Runway slope / Landing Area Slope

Issue identified NPA 2018-06 (B-C-D)

Thierry Bourret
13th October 2018

AIRBUS

Illustrative exemple of Calvi (LFKC)

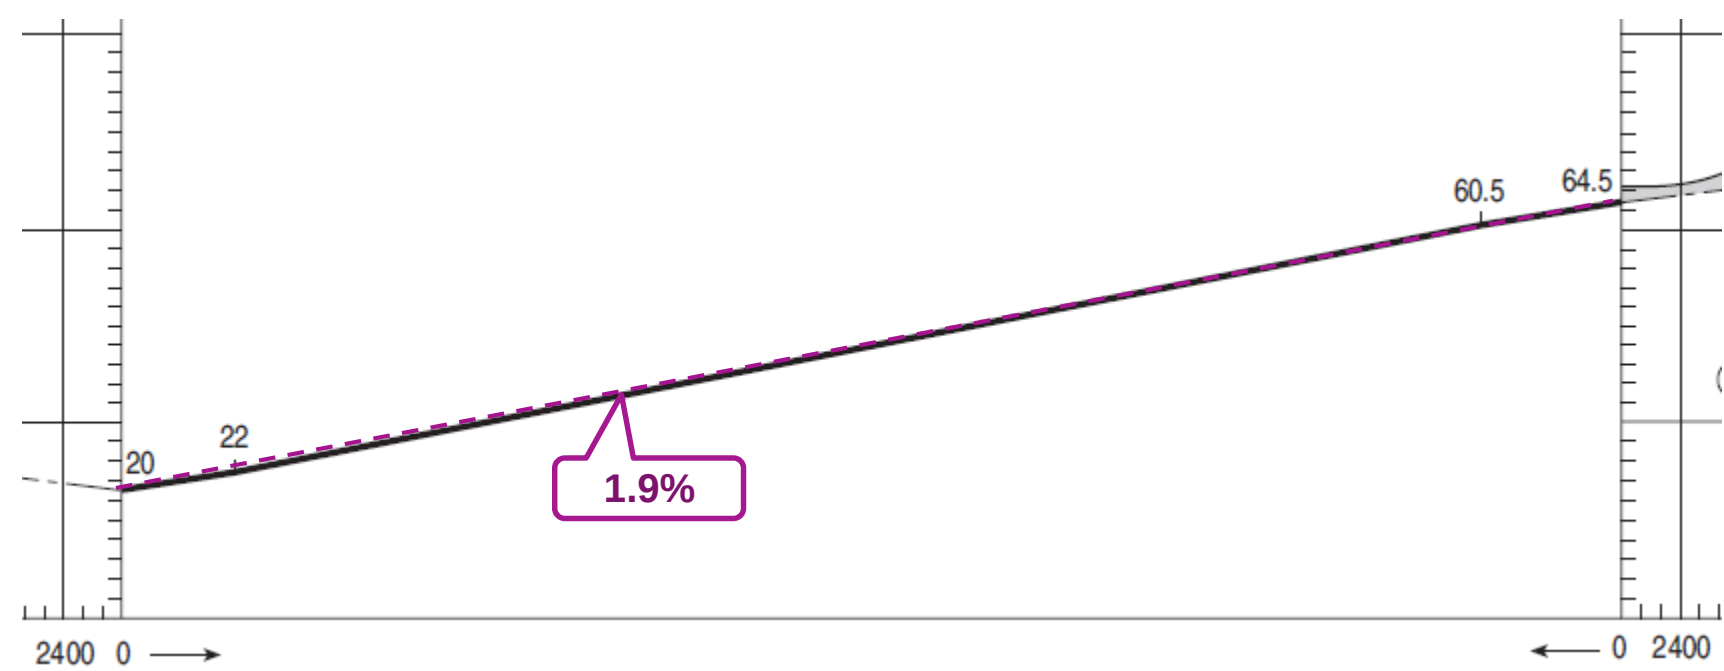
Issue for runway with variations of slopes
